# **Statement of Response to Pre-application Consultation Opinion**

**Lands at the Former Dulux Factory Site,  
Davitt Road, Dublin 12, D12 C97T**

**Residential Development**

**On behalf of  
Durkan (Davitt Road) Ltd**

Central Courtyard Landscape Plan

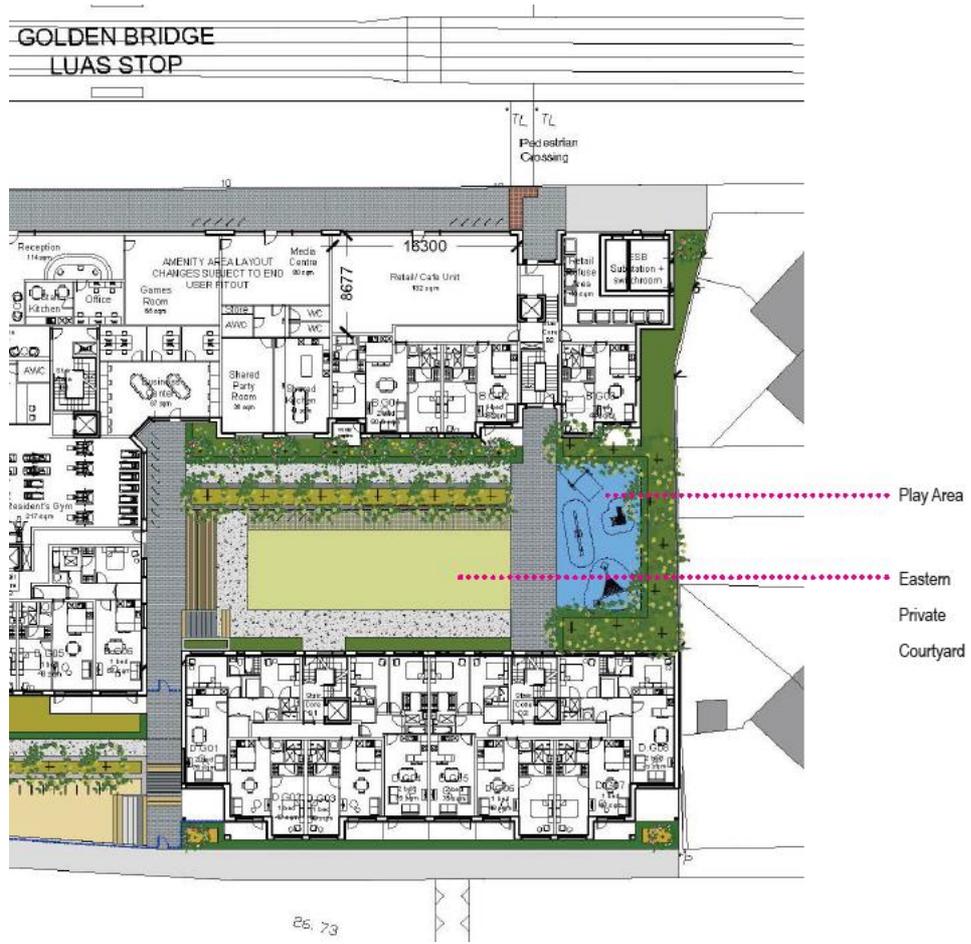
An Bord has requested a report that specifically addresses the proposed materials and finishes of the proposed structures including specific detailing of materials and finishes, openings and privacy screening, landscaped areas, pathways, entrances and boundary treatment/s. The lighting of public spaces should also be addressed. Particular regard should be had to the requirement to provide high quality and sustainable finishes and details which seek to create a distinct character for the development given its strategic location and the visibility of the site. The documents should also have regard to the long term management and maintenance of the proposed development.

The central courtyard is the primary space and opens up a new access from Galtymore Road through to Davitt Road, forming the primary circulation route to the Goldenbridge Luas stop. The central courtyard represents significant planning gain as it provides a new north south link between Galtymore Road and Davitt Road. A plan of the central courtyard area is shown below.
